ASSESSMENT REPORT

Section 75W Modification Modification to Waste Management Facility – Hazardous and Restricted Waste (06_0095 MOD 4)

Figure 5: Proposed Weighbridge Location and Alternatives

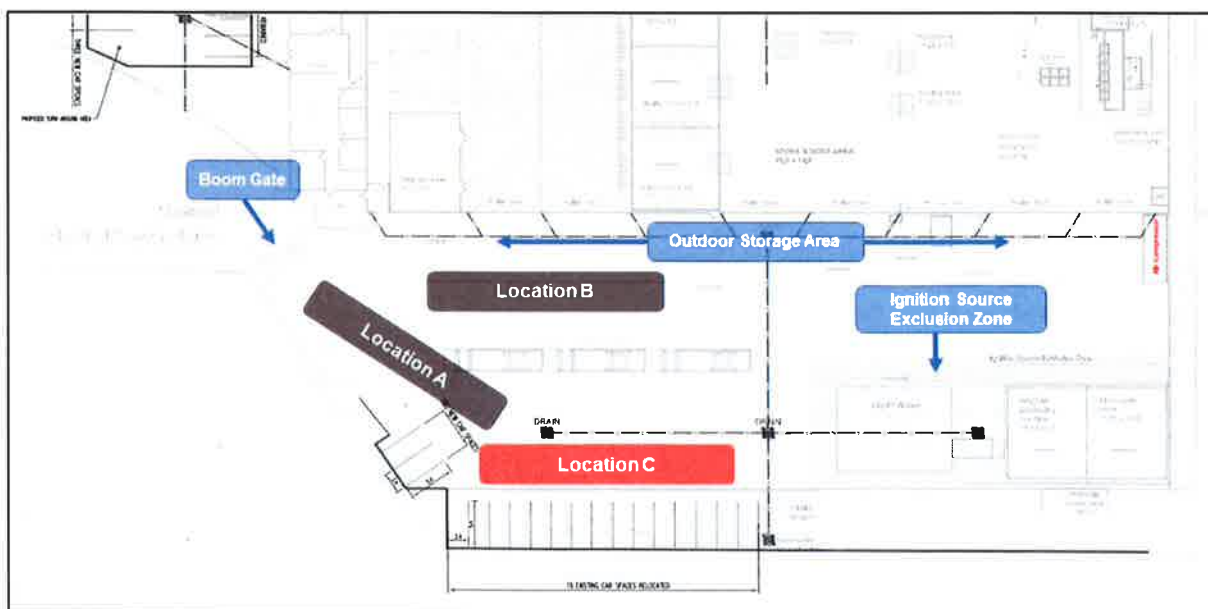
The proposed amendments include the installation of an in-ground weighbridge which has the potential to impact vehicle manoeuvrability and safety within the loading dock area, especially considering the hazardous nature of waste being transported and the proximity of the ignition source exclusion zone.

The 22 m x 3.5 m in-ground weighbridge is necessary for the facility to comply with the EPA's requirements for waste tracking. When the Proponent lodged the modification request, the proposed weighbridge location was in "Location A" depicted in **Figure 5**. The Department requested a swept path analysis which demonstrated heavy vehicle conflicts with the existing boom gate, ignition source exclusion zone and outdoor storage area as well as providing minimal margin for driver error in manoeuvres adjacent to the western façade of the building. The Proponent subsequently amended the plans and included an options analysis, illustrating swept path analysis manoeuvres for semi-trailers (the heaviest vehicle to access the site) for "Location B" and "Location C" as depicted in **Figure 5**. The Proponent determined "Location C" to be favourable and amended the proposal to reflect this.

Figure 6: Swept Path Diagram Demonstrating Loaded Vehicle Entry onto Weighbridge

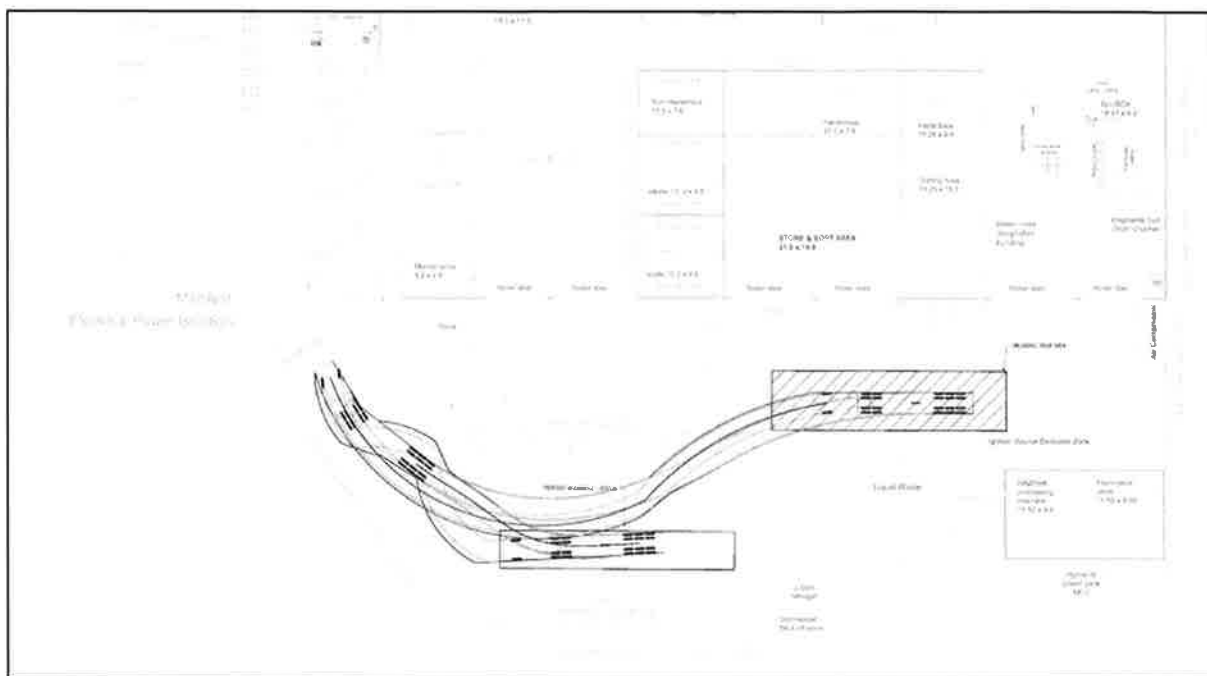
The swept path analysis submitted also demonstrates that some required heavy vehicle manoeuvres would be complex (as shown in **Figure 6**) due to the restricted size of the site and may have the potential to cause conflicts with other vehicles accessing the site. This would be compounded by the one-way nature of the site access, limited queuing area in the driveway and other loading requirements of the site. It is the Department's view that protocols are necessary to avoid traffic conflicts especially considering the potentially hazardous nature of the wastes. It is therefore recommended a condition be imposed requiring an Operational Traffic Management Plan (OTMP) be prepared and submitted to the Secretary for approval prior to construction of the weighbridge. The OTMP should address the management of light and heavy vehicle conflicts, scheduling of vehicle arrivals and departures, management of multiple vehicles on site at any given time and accident management/response.

The Department's assessment concludes that the impacts of the weighbridge on internal vehicle manoeuvrability could be adequately managed through mitigation measures including the implementation of an OTMP and the Proponent has provided an appropriate amount of car parking.
